**ARCHITECTURAL REVIEW BOARD
MUNICIPAL PLANNING COMMISSION
-AGENDA-
Thursday, October 13, 2016 at 7:00 P.M.**

MEMORANDUM

SUBJECT: Staff Memo for the Meeting of October 13, 2016

1 (4) AXON (NE)
EX-ARB-15 SCALE:

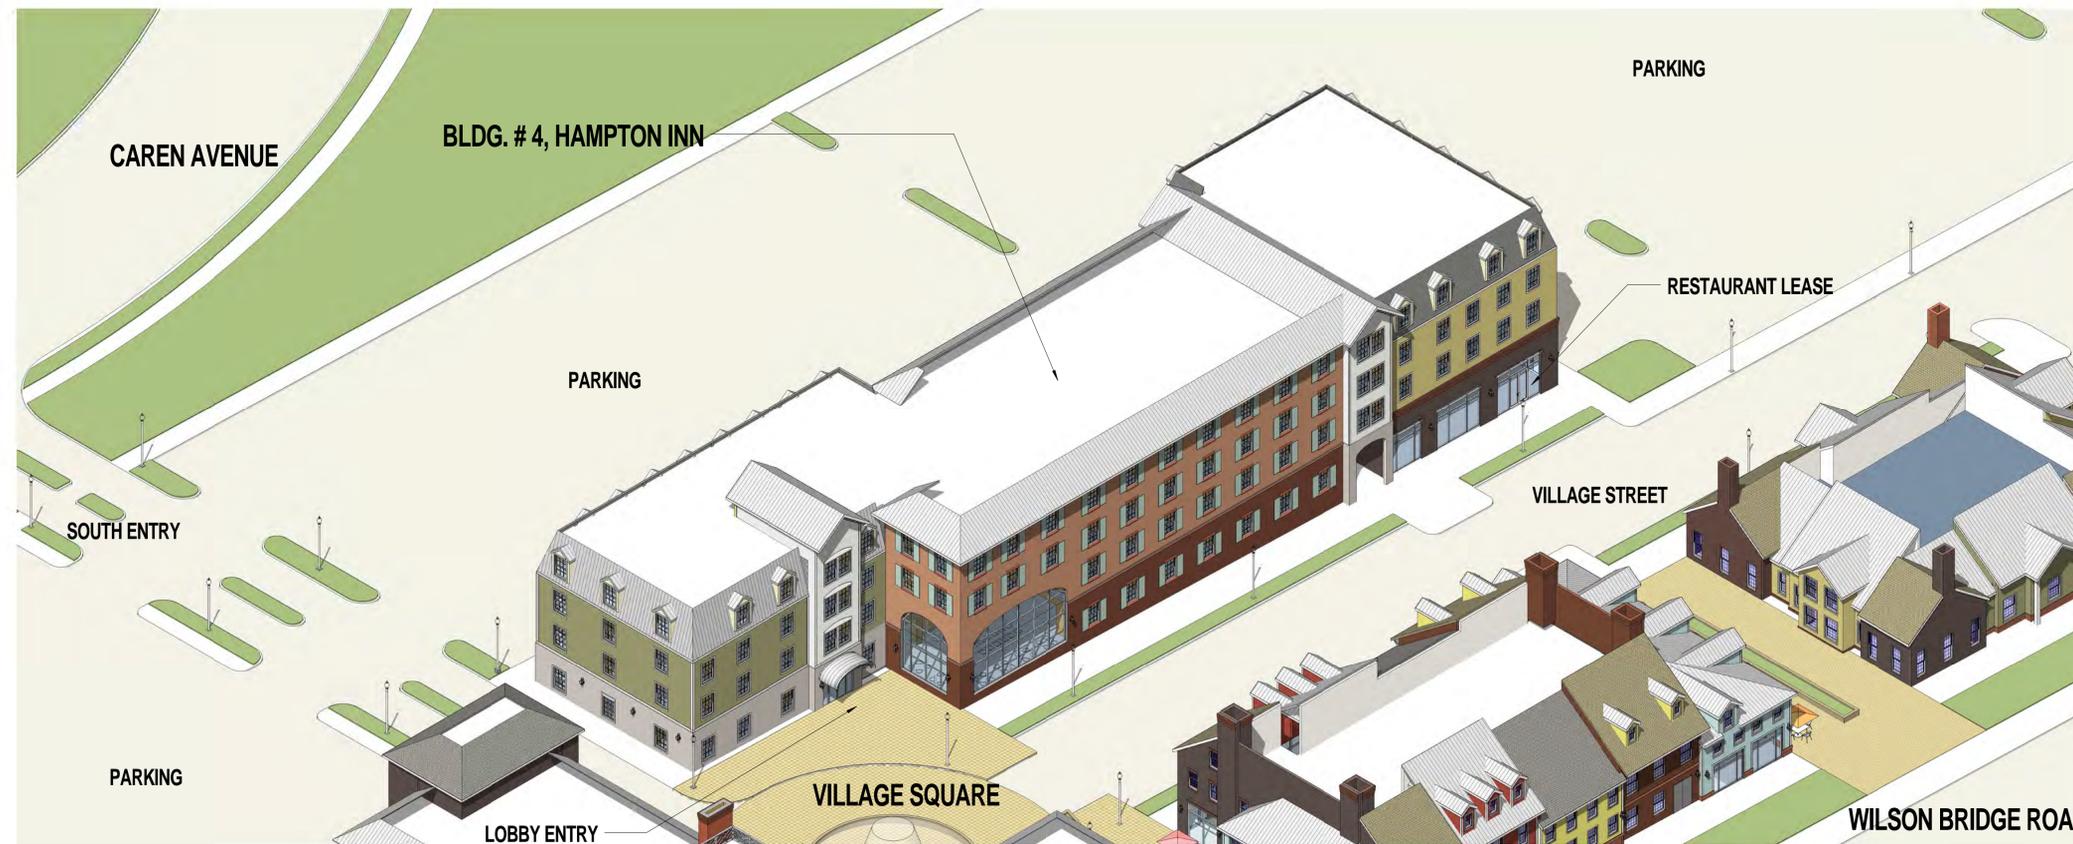
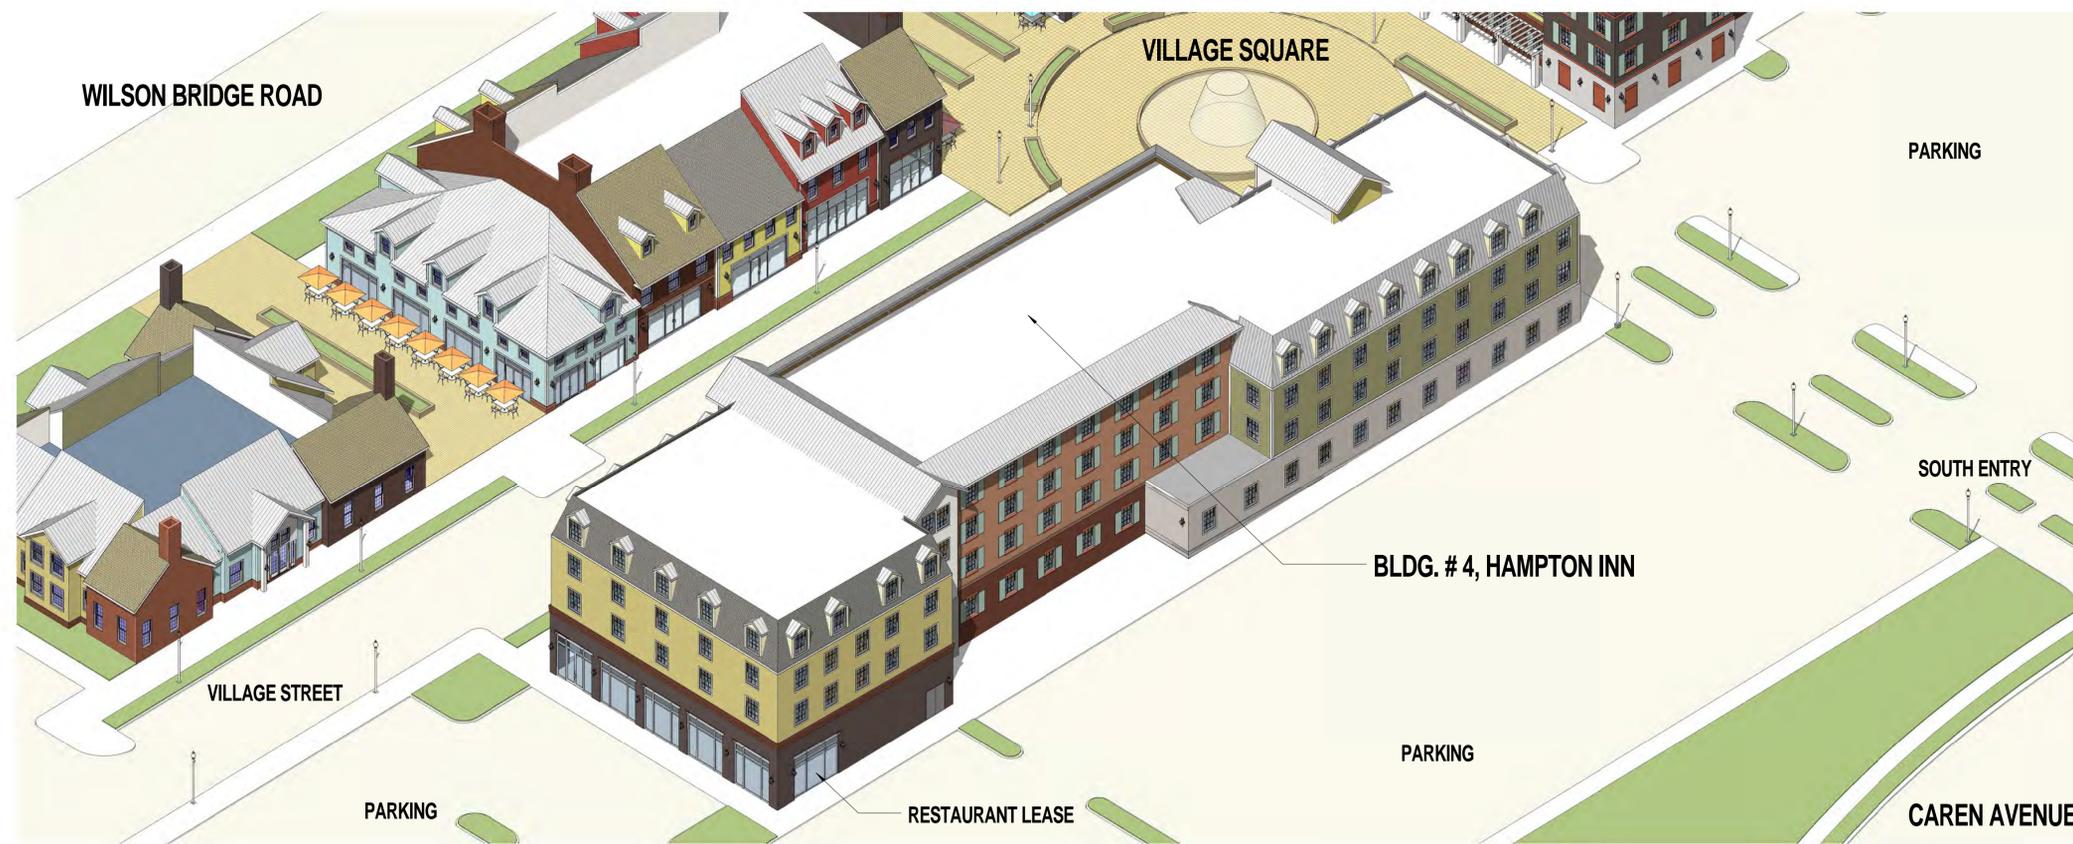
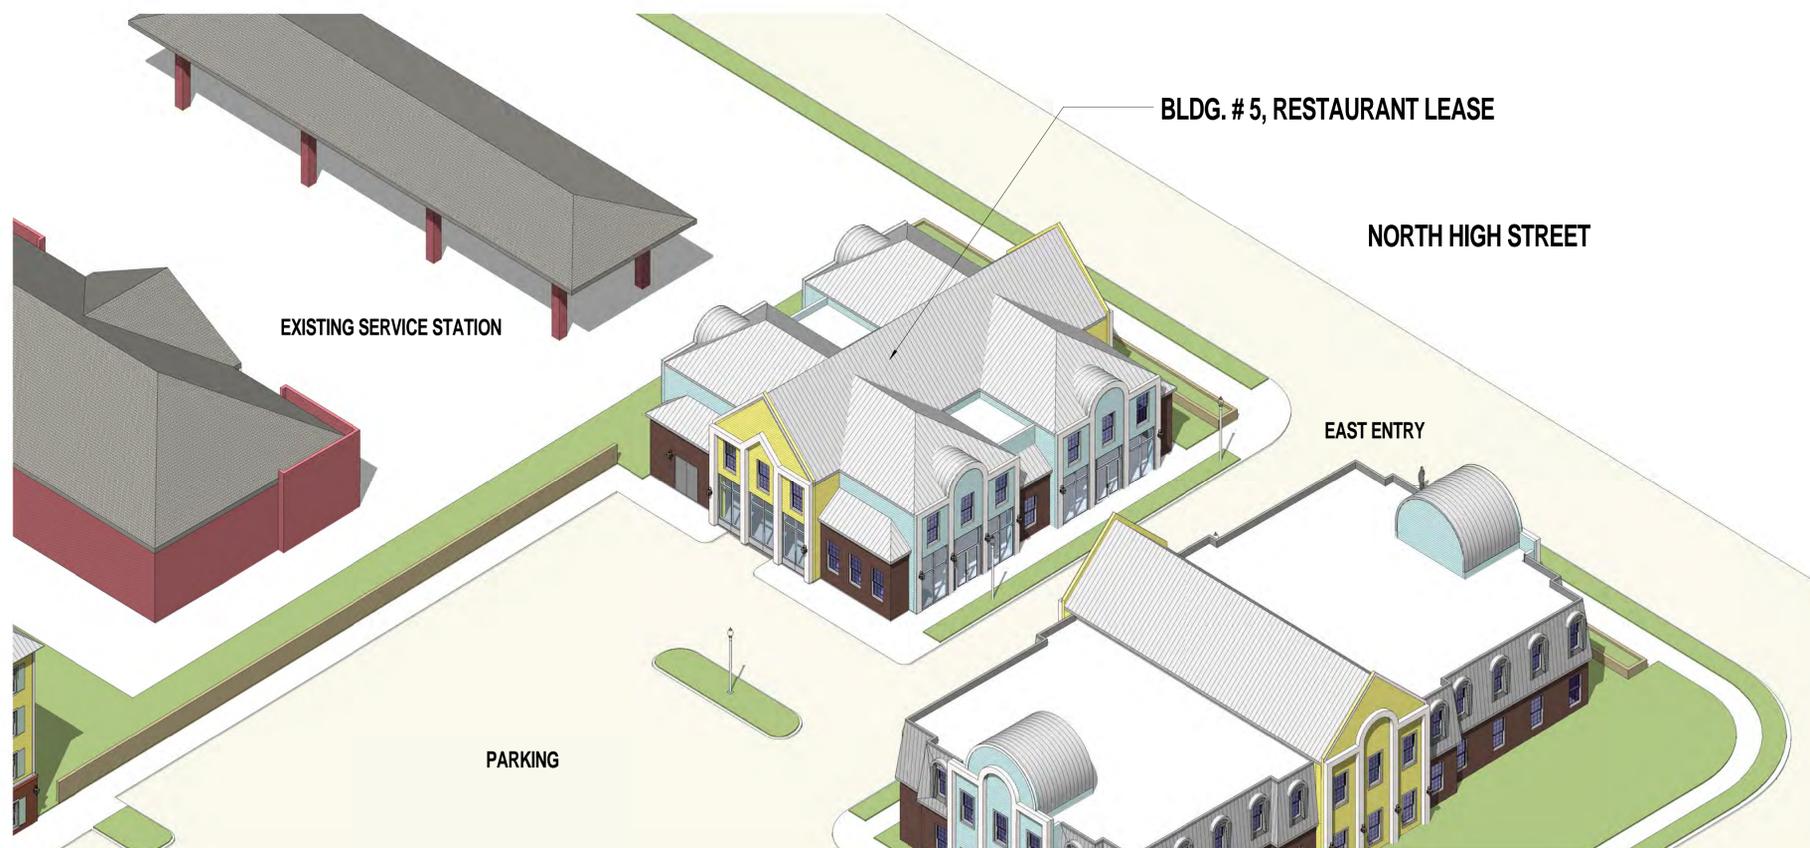
- The buildings are all shown as having four-sided architecture that is described as Colonial style. A variety of building heights, roof forms, materials and details are proposed across the site. A sheet with a large variety of proposed materials is included in the packet. The renderings do not necessarily reflect the exact color and

- A simpler mix of materials and colors may be warranted. The extensive use of lap siding, bright colors and metal roofing, especially on the larger buildings, does not seem appropriate. A simpler more subtle use of colors could provide a development that fits in better with Worthington.

4. Staff is recommending *tabling* of this application after discussion, to allow the applicant to make modifications and add detail based on the guidelines and any recommendations made at the meeting.
